Evidence prepared for
Mount Atkinson Holdings Pty Ltd

2 September 2016

Traffic Engineering
Expert Evidence Statement

Amendment C162
Mt Atkinson and Tarneit Plains
Precinct Structure Plan

Figure 4.1: PSP Road Network Plan

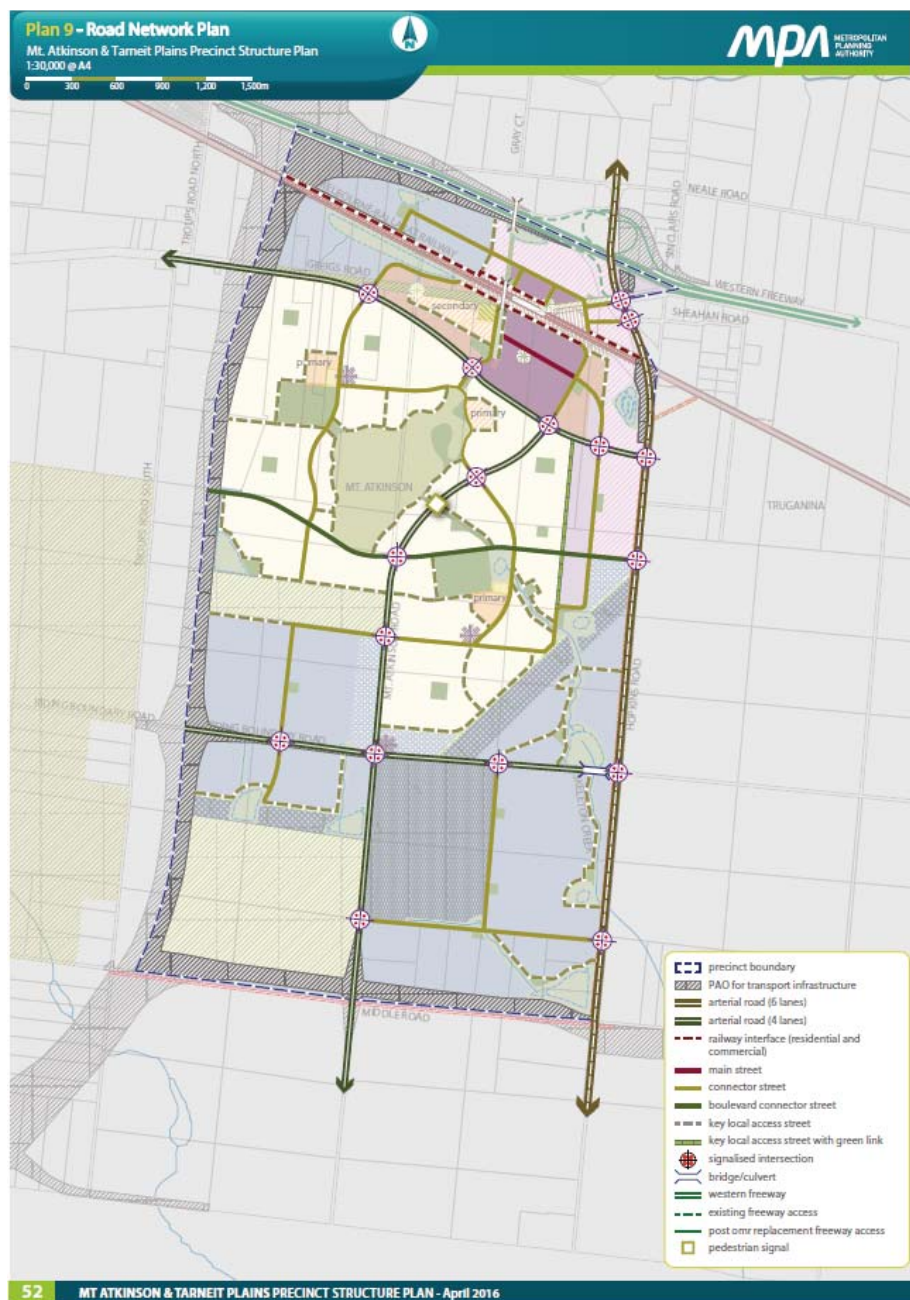
- 4.3.5 A number of ‘Key Local Access Streets’ are shown on the Road Network Plan. There is no cross section in Appendix D or Appendix E that refers to such a cross section, this will lead to confusion and different interpretations as to what is a ‘Key Local Access Street’.
- 4.3.6 Regardless, the inclusion of Access Streets of any kind within the Road Network Plan, which is intended as an indicative guideline of the higher

- 4.3.7 A number of the Access Streets are showing highly curved alignments that may not reflect good road design and are unlikely to be appropriate in some areas, such as the industrial use zone, which may require access by large trucks.

- 4.3.8 The alignment of access streets should be determined at the time of subdivision, when the topography of the site, the pattern of subdivision and other constraints are better understood.

- 4.3.9 Three of the key local access streets aligned east west, are shown as ending at their junction with the OMRR. Local Access streets will not intersect with the OMRR, therefore it is unclear whether the intention is to provide dead end streets or that an under / overpass will be constructed. The likelihood of three under / overpasses seems unlikely.

- 4.3.10 In my opinion the local roads should be removed from the plan, however if they are to remain, then the intention of the road connection should be clarified.

Figure 4.2: Hopkins Road / Western Freeway Interchange

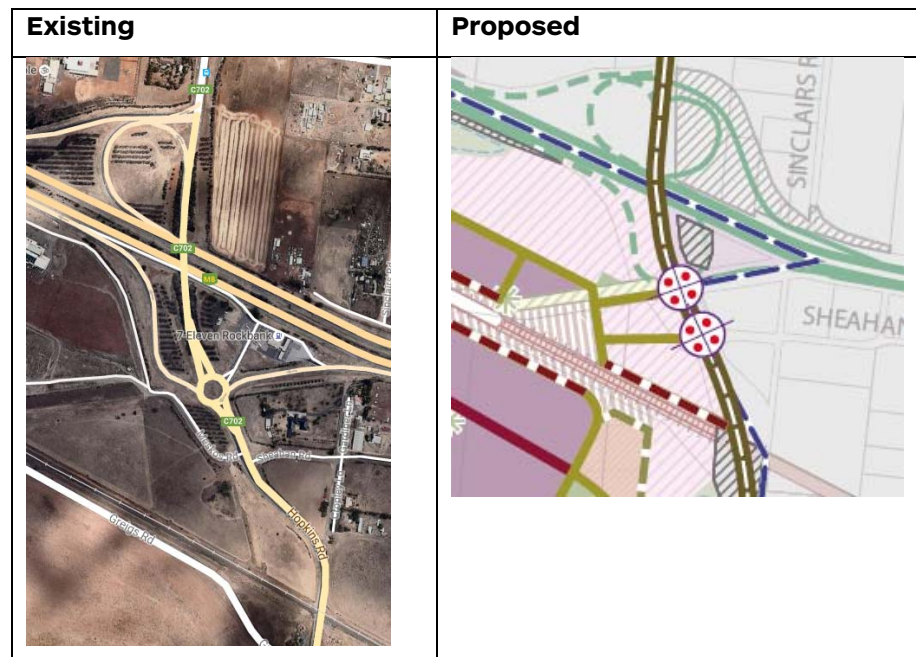
- 4.3.11 The proposed traffic signal intersection spacing is generally considered satisfactory, with the exception of the two proposed traffic signals on Hopkins Road immediately south of the Western Freeway. The existing geometry and the proposed intersection spacing is shown in Figure 4.2.

- 4.3.12 The existing intersection spacing between the Western Freeway westbound off ramp and Sheahans Road is approximately 170 metres.
- 4.3.13 The proposed intersection spacing in the PSP also appears to be 170m, which is undesirably close.
- 4.3.14 It is noted that in order to provide two way access to the west at the northern traffic signal, that the existing on ramp will need to be relocated to the eastern side of the intersection and through the service station site to the Western Freeway.

- 4.3.15 What this means in practical terms is that the northern traffic signal will be unable to be constructed without modifying the Western Freeway on ramp, which affects the existing service station land use.

- 4.3.16 The southern traffic signal of the two is only required in order to facilitate access to land use east of Hopkins Road. However the Road Network Plan doesn't show an eastern leg at this intersection, which should be amended.

- 4.3.17 In order to ensure future developers of land in the vicinity of the two traffic signals understand the implications regarding freeway access modifications, either the PSP should include additional discussion around these items or a clear diagram demonstrating the proposed changes to the Western Freeway on-ramp should be included.

- 4.3.18 The road shown as railway interface (residential and commercial) which is shown in the preceding figure as west of Hopkins Road immediately north of the railway line, should be removed from the Road Network Plan.

- 4.3.19 Assuming that the Hopkins Road railway crossing will be grade separated at some point, the proposed Rail Interface intersection with Hopkins Road will be difficult to include in any grade separation and as such should be removed from the PSP Road Network Plan. An appropriate local road network can be designed to the satisfaction of the Responsible Authority at the time of a planning application for the surrounding land uses.

Figure 4.4: Public Transport and Path Network Plan Issues

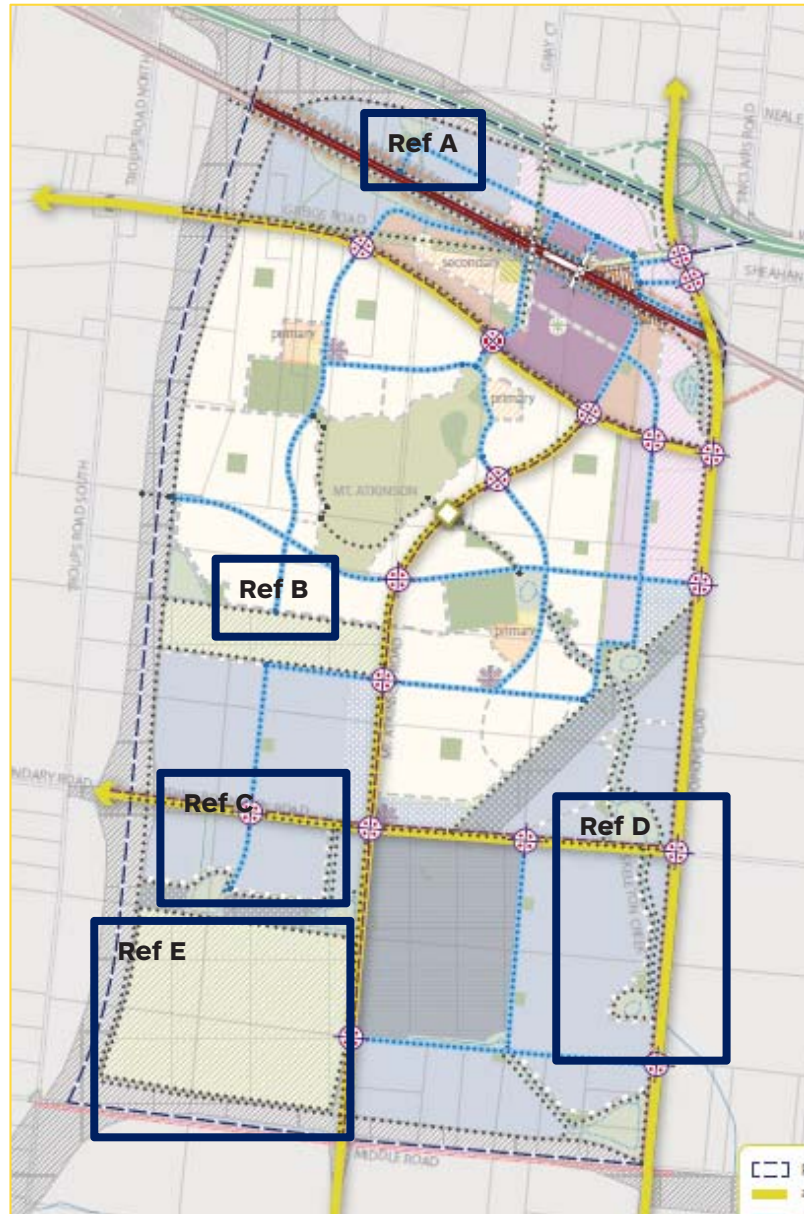
- 4.5.1 I have reviewed the proposed public transport and paths network diagram and have identified the areas highlighted on Figure 4.4 that need further clarification.

Figure 4.5: Bus Routes shown as dead ends

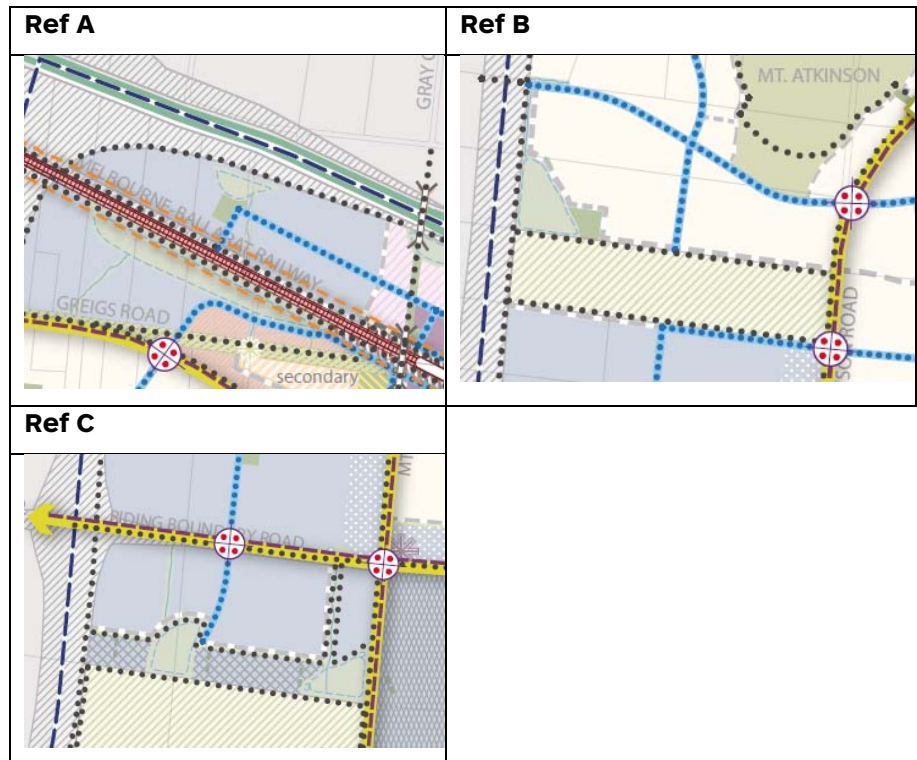
- 4.5.3 Several roads nominated as 'bus capable' are shown as dead ends. This is considered undesirable from a public transport network perspective, as buses would have to travel along these roads and complete a u-turn at the end, in order to get back to the circulatory road network.
- 4.5.4 It is considered highly unlikely that any of the dead ends would ever facilitate bus movements and as such should be removed from the Public Transport plan.

Figure 4.6: Unnecessary Duplication of Path Network

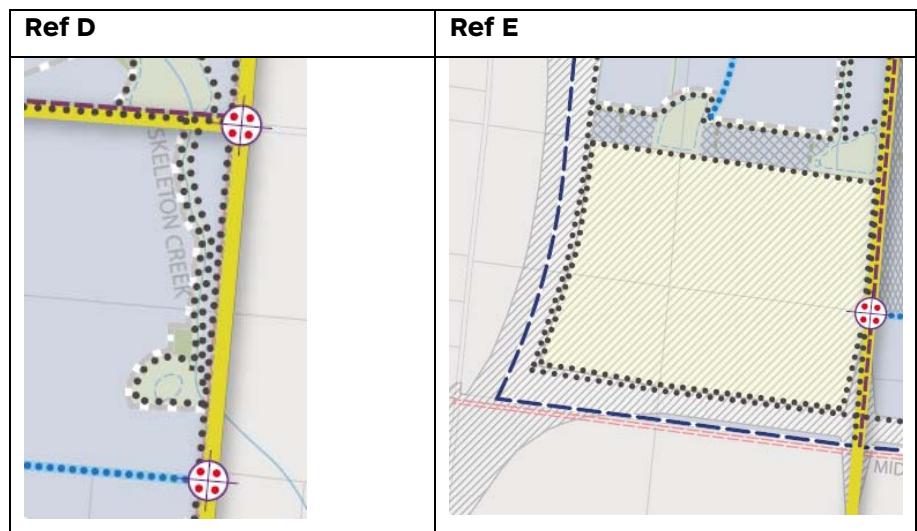
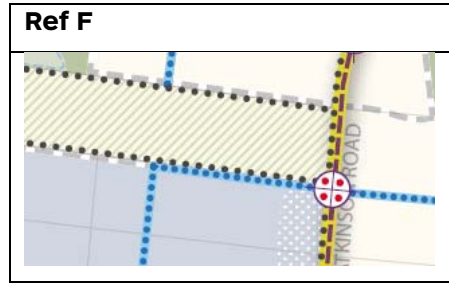
- 4.5.6 As shown in Reference D, it is proposed to have the off road bike path along the western side of Hopkins Road, plus an off road shared path within the High Pressure Gas Easement, as well as off road shared paths along both sides of Skeleton Creek.

- 4.5.7 Based on Nearmap the existing alignment of Skeleton Creek is approximately 170 metres west of Hopkins Road at the location of Riding Boundary Road. Therefore the PSP is proposing 4 paths within 170m or less all capable of accommodating bicycles.

- 4.5.8 The shared path on the eastern side of the Skeleton Creek south of Riding Boundary Road is considered unnecessary and should be removed from the path network.

- 4.5.9 As shown in Ref E, 2 shared paths seem to be shown on the eastern, southern and western sides of the conservation area. A single path around the perimeter of the conservation space within the abutting road reserves would be appropriate.

- 4.5.11 Similar to the above, in my opinion there is no need to provide an off road bicycle path beside an off road shared path as shown in Ref F. In my opinion the north south off road bike path should end at the conservation area and transition into the off road shared path, up to the North South Secondary Arterial.

Figure 4.7: Cross Section 2, Secondary Arterial

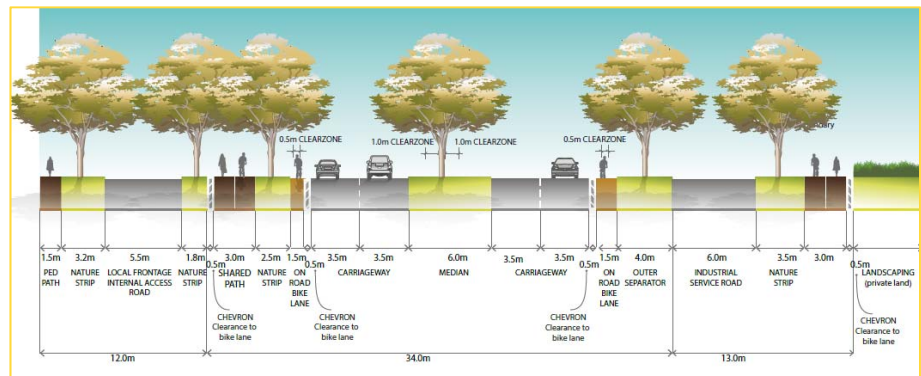
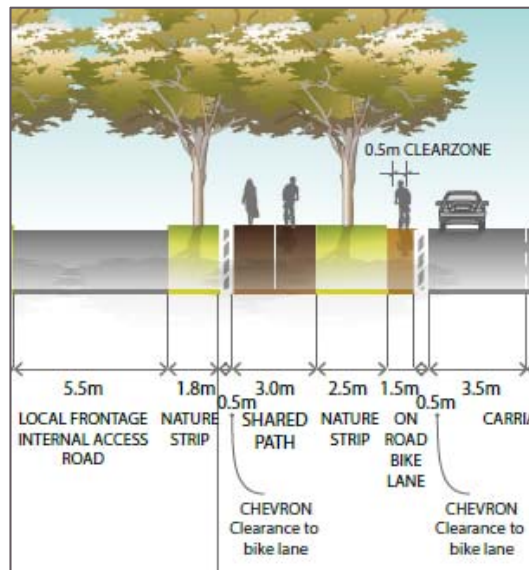
- 4.6.2 The preceding cross section indicates a 500mm chevron cross hatching on one side of the 3.0m shared path on both sides of the cross section shown in Figure 4.7. In my opinion the 3.0m width is sufficient for a shared path and does not need to be increased by a further 500mm.
- 4.6.3 The chevron linemarking also increases the required maintenance of the path and in my opinion provides no obvious benefit.

Figure 4.9: Cross Section 9, Boulevard Connector Road

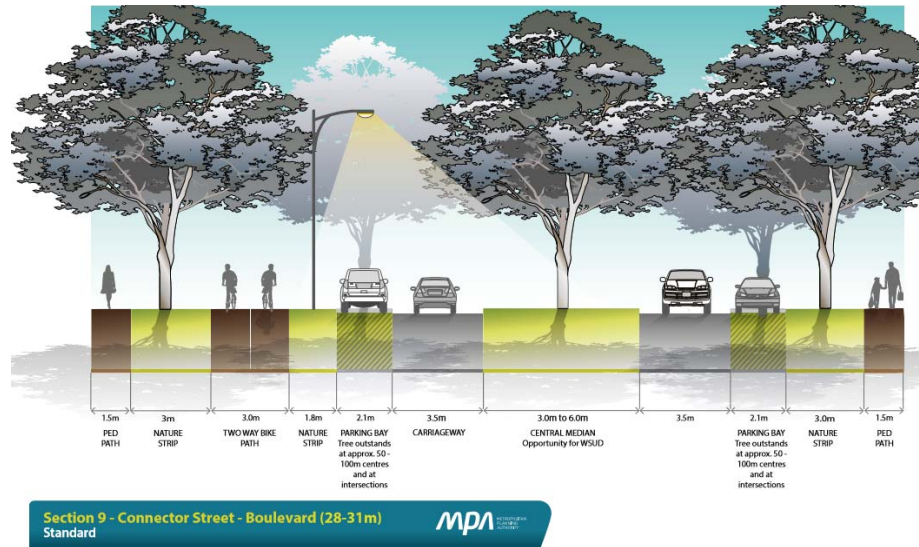
- 4.6.10 As shown in the cross section above it is proposed to have a single 3.5 m carriageway with indented parking separated by a central median of 3.0 to 6.0 metres.
- 4.6.11 The PTV design guidelines for a bus route with a median require a minimum lane width of 5.5 metres when there is no on road bike lane and a clear zone of 7.5 metres. On this basis and my experience with similar road cross sections, it is unlikely that PTV will support the proposed cross section as a bus route.

Figure 4.10: Activity Centre Concept Plans

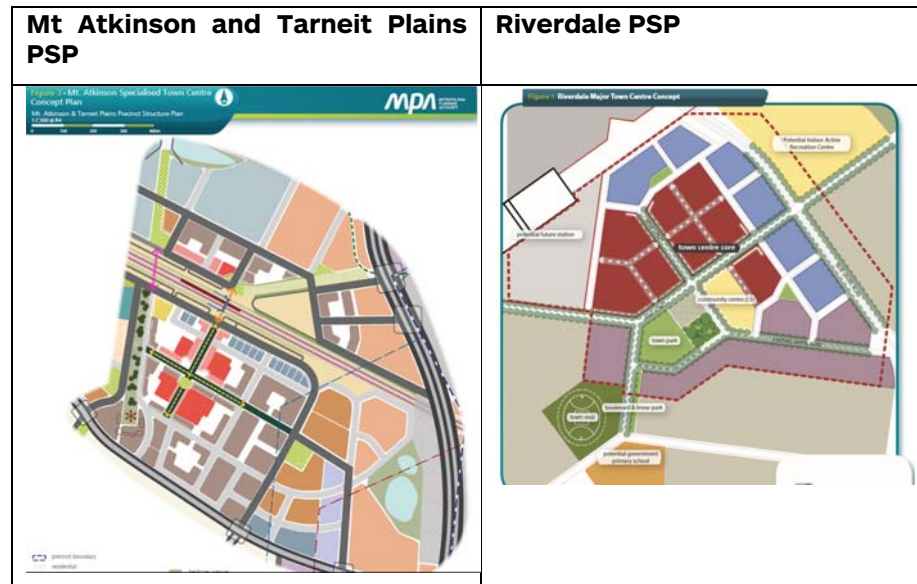
- 4.8.1 As per the preceding discussion on the Industrial Land Concept Plan, it is my opinion that the Specialised Town Centre Concept Plan is also overly prescriptive.
- 4.8.2 The proposed PSP concept plan is shown in Figure 4.10 and compared to the Town Centre Concept Plan prepared for the Riverdale PSP area.

- 4.8.3 As shown in the preceding comparison considerably more detail is shown on the Mt Atkinson and Tarneit Plains Town Centre Concept Plan than in the Riverdale PSP.
- 4.8.4 In my opinion the Riverdale PSP example on the right, provides a better level of flexibility for future development.

Figure 5.1: Proposed Greigs Road / Connector Road Intersection Alignment

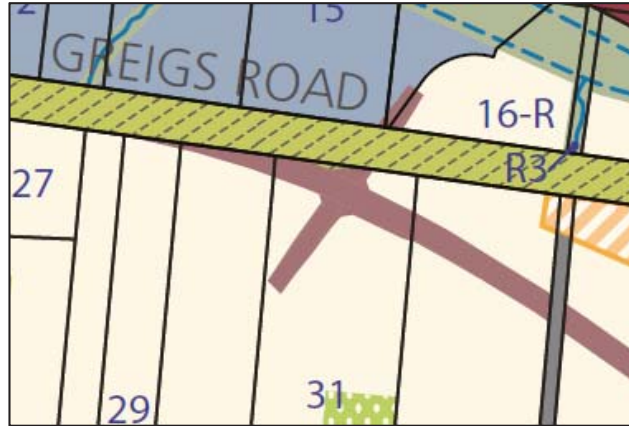
- 5.2.1 The proposed PSP intersection is estimated to be displaced from the existing road reserve by in the order of 40 metres. The offset is insufficient to enable the proposed intersection to be constructed, whilst still maintaining through traffic on Greigs Road.
- 5.2.2 The angle of the proposed intersection also poses problems for anyone wishing to construct an interim intersection treatment. The angle of the proposed intersection, would result in a skewed approach, rather than 90 degrees (as per good design practice), to Greigs Road in an interim design that matched into the existing Greigs Road alignment.

- 5.5.1 Based on the preceding discussion it is my opinion that the proposed Connector Road intersection, east of the future OMRR, should be located within the existing Greigs Road, road reserve, to allow the construction of an interim intersection treatment, to facilitate residential development south of Greigs Road in the near future.
